SOUTH TEXAS PROJECT
UNITS 1 AND 2

DOCKET NOS. 50-498 AND 50-499

FINAL ENVIRONMENTAL STATEMENT

Issued: March 1975

Fig. 2.2. Site development plan. Source: PSAR, Fig. 2.1-4.

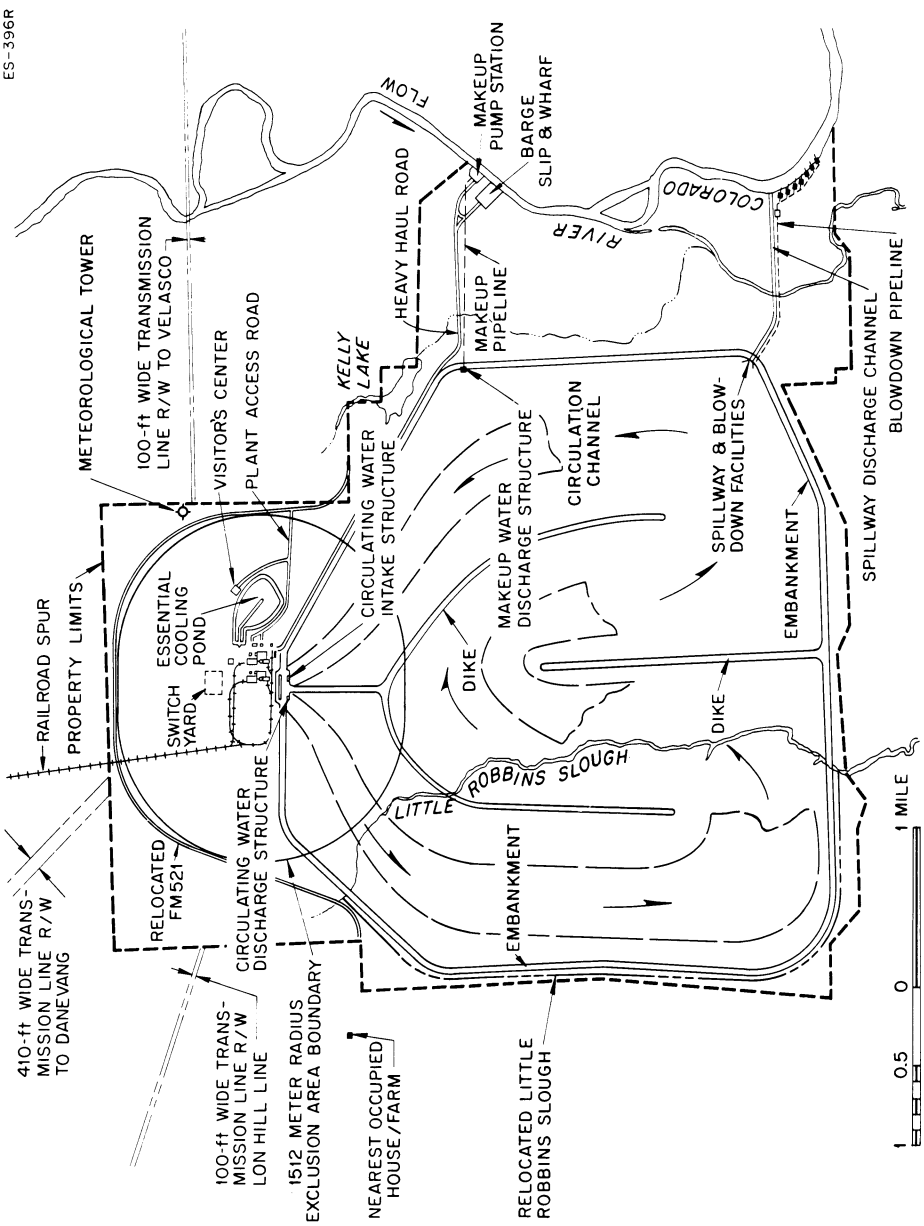
Figure 2.2 should be replaced with revised Figure 3.4-1 from Amendment 3 to the ER.

Fig. 2.5. South Texas Project vegetation and land use types, 1974.
Source: ER, Suppl. to Amendment 1.

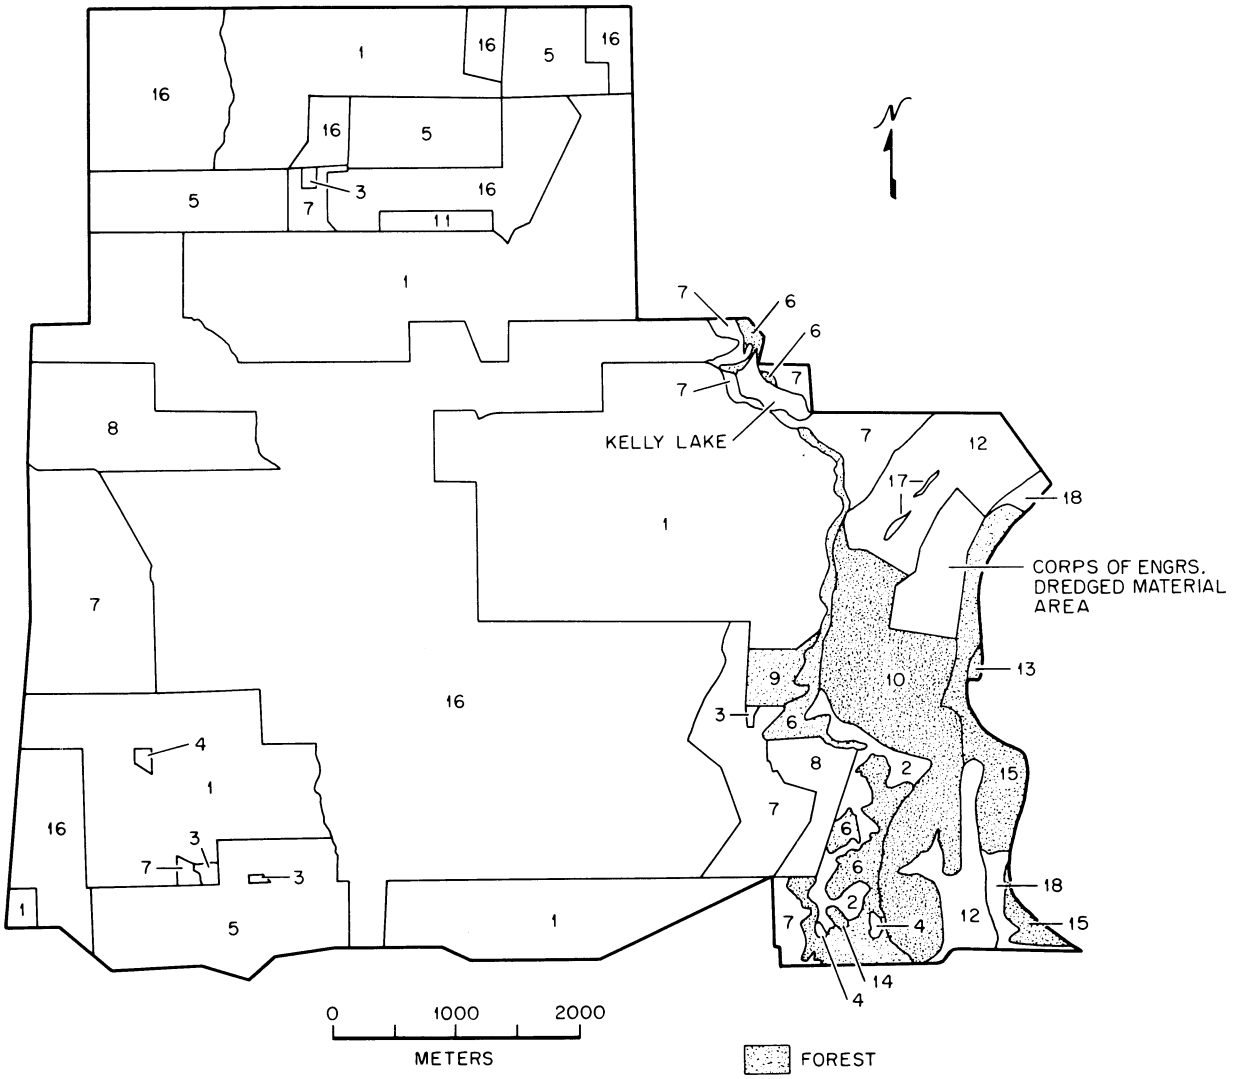
d. Page 2-12: Fig. 2.5 clarify arrows depicting Robbins Slough and/or Little Robbins Slough.

Fig. 3.2. Plant water use diagram. Source: ER, Amendment 3, Fig. 3.3-1.

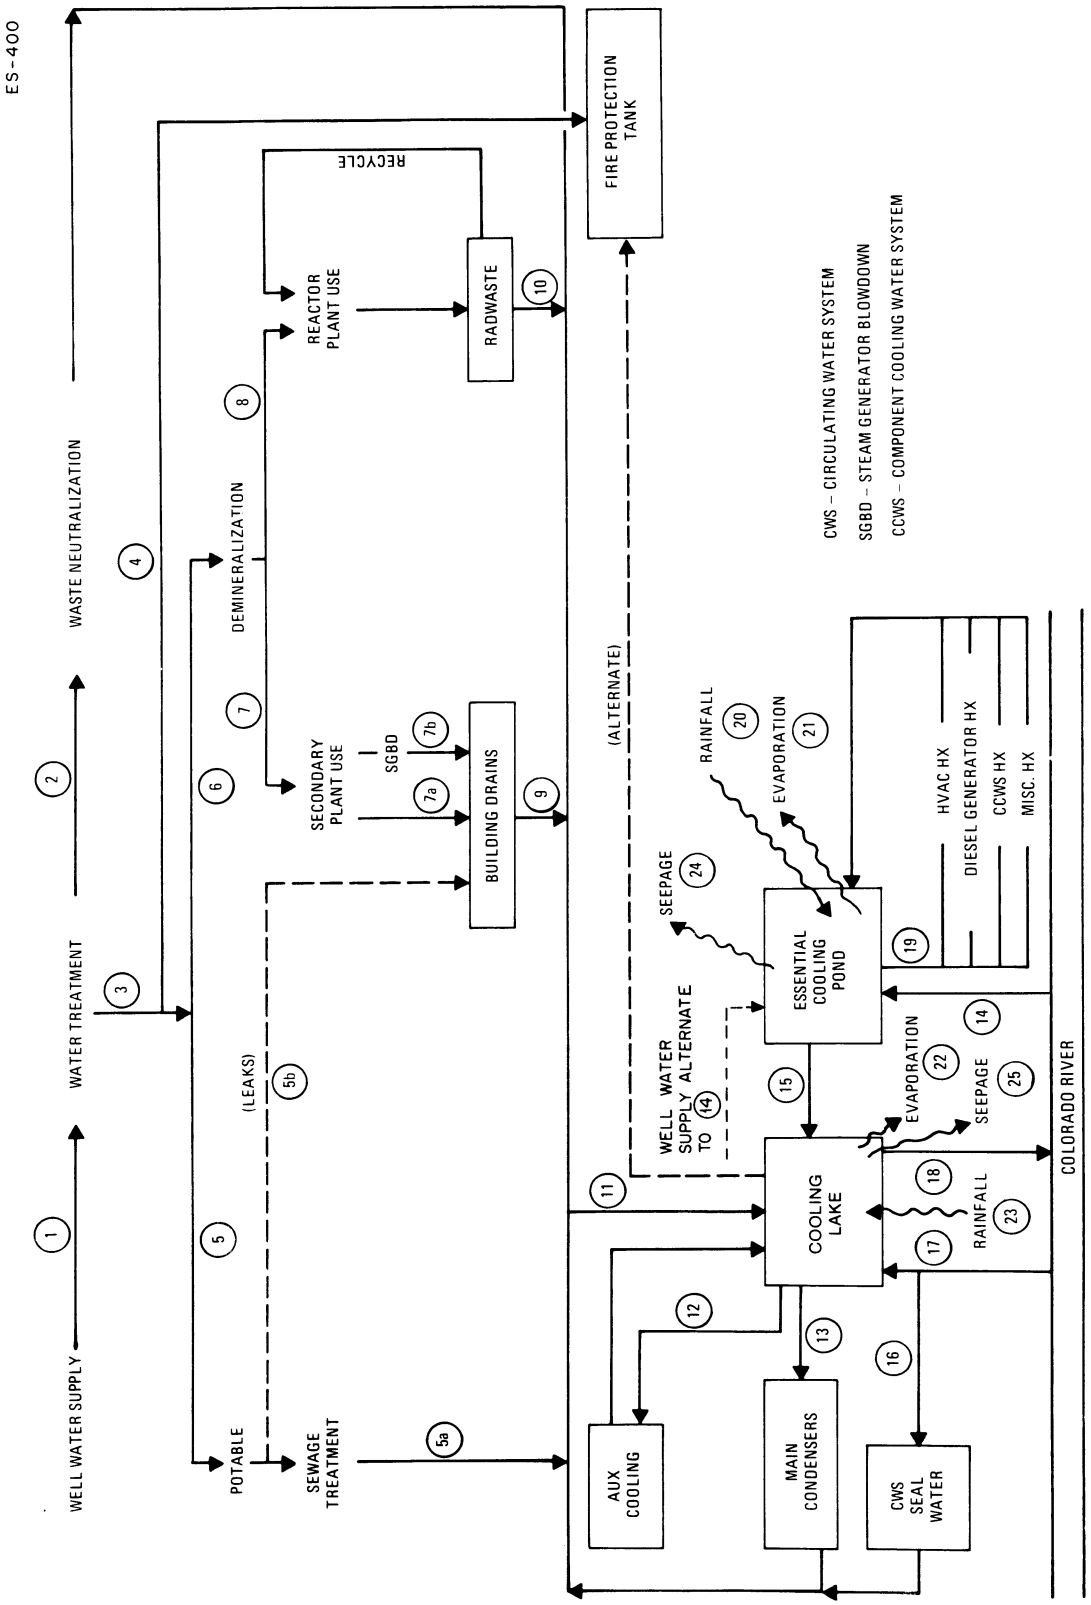
Page 3-4, Figure 3.2

This figure should be revised according to ER Figure 3.3-1 as revised in Amendment 3.

The text in Section 3 consistently refers to the water flow diagram as Figure 2.2. It should be Figure 3.2. This needs to be corrected.

Fig. 3.6. Permissible cooling lake blowdown rates. (a) Freshwater flow rate of Colorado River at spillway, cfs. (b) Required total Colorado River flow rate at spillway, cfs. Source: ER, Fig. 3.4-11.

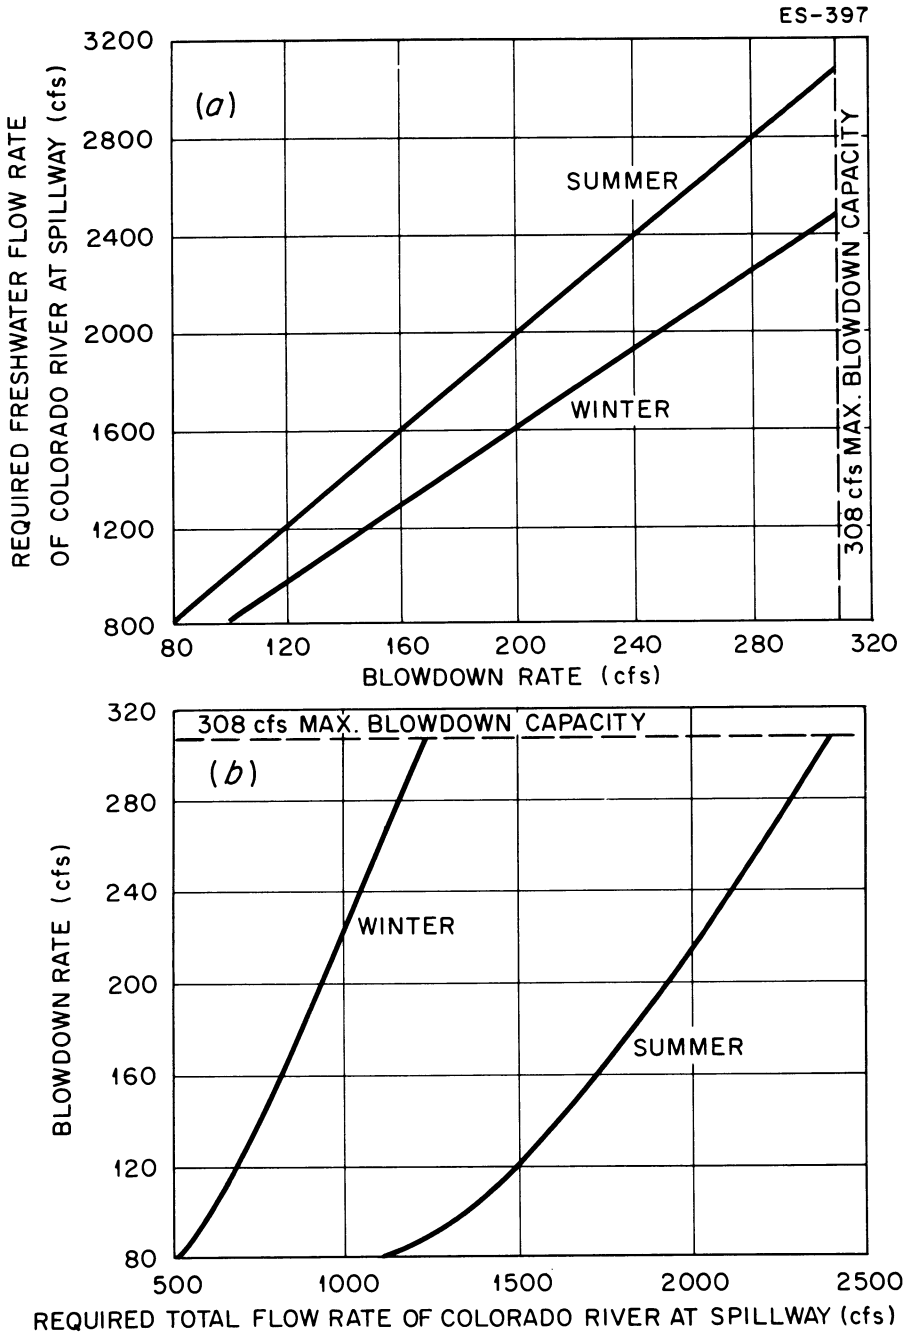
The most serious problem with this statement is the discussion of the freshwater requirement and the availability of water from the Colorado River. Section 2.5.1.1 indicates the average Colorado River flow is 2353 cfs. Figure 3.6 shows a possible freshwater requirement of nearly 3000 cfs. This requirement obviously could not be met on any sustained basis. The more detailed data in Table 5.16 show river flows up to 7000 cfs and makeup water flows up to 1200 cfs. These appear to be compatible; unfortunately, they don't necessarily agree with the earlier citations. The water requirement should be reviewed not only for internal consistency but also to assure that adequate water will be available for the plant operation. It may even be necessary to select an alternative cooling system design which requires less water.

Fig. 3.7. Liquid radioactive waste treatment system for the South Texas Project.

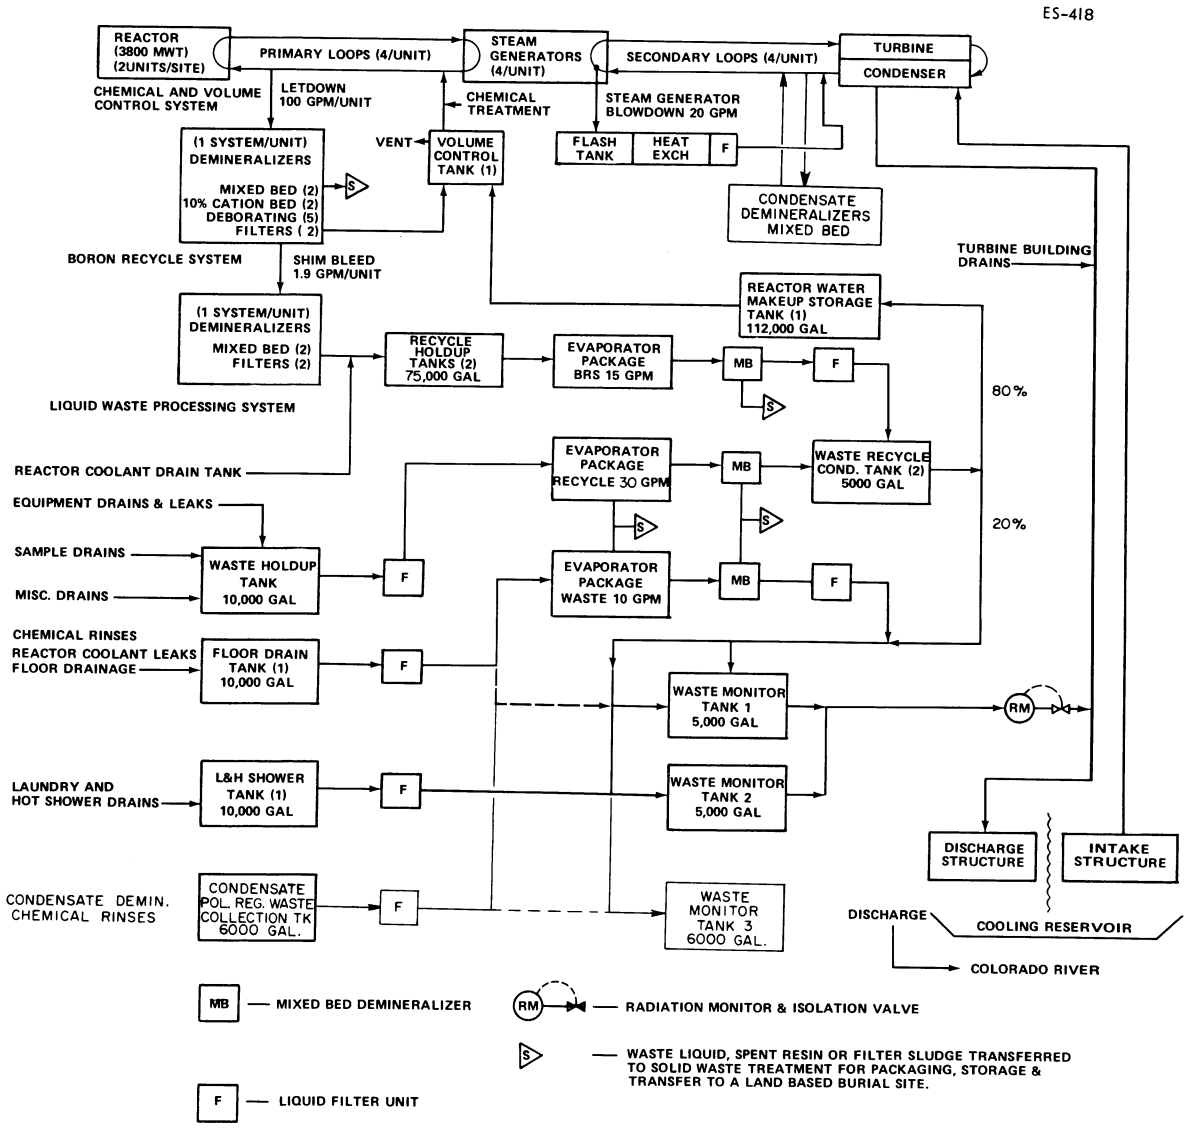
Figure 3.7

The "Laboratory and Chemical Drain Tanks" should be relabeled "Condensate Polishing Regeneration Waste Collection Tank" and resized to 10,000 gallons. Thus the DES should indicate that flow from this tank will be through a filter to an additional Waste Monitor Tank (#3) with optional flow through the WPS Waste Evaporator demineralizer package. (See ER Figure 3.5-2, Amendment #2.)
